UNITED STATES
DEPARTMENT OF THE INTERIOR
BUREAU OF LAND MANAGEMENTFORM APPROVED
OMB NO 1004-0135
Expires July 31, 2010**SUNDRY NOTICES AND REPORTS ON WELLS**
*Do not use this form for proposals to drill or to re-enter an abandoned well. Use form 3160-3 (APD) for such proposals.***SUBMIT IN TRIPLICATE - Other instructions on reverse side.**

BP - San Juan Plugging Procedure

GCU 336
30-045-25470

Re Permanent Abandonment
Well: 336 Gallegos Canyon Unit

Current Wellbore Diagram

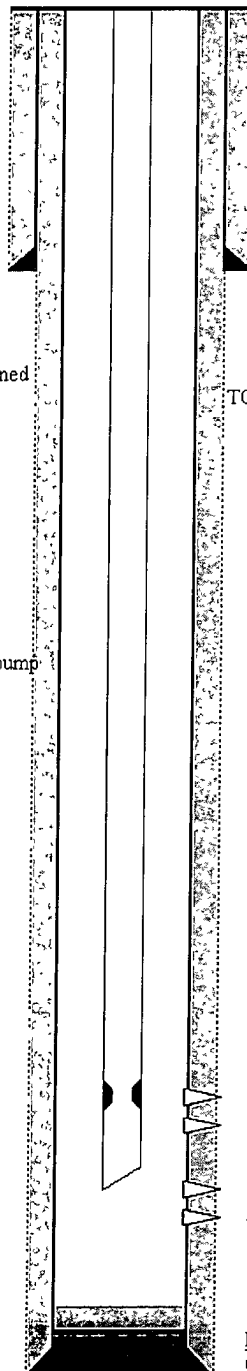
3 The following modifications to your plugging program are to be made

a) Bring the top of the Pictured Cliffs/Fruitland plug to 1142'.
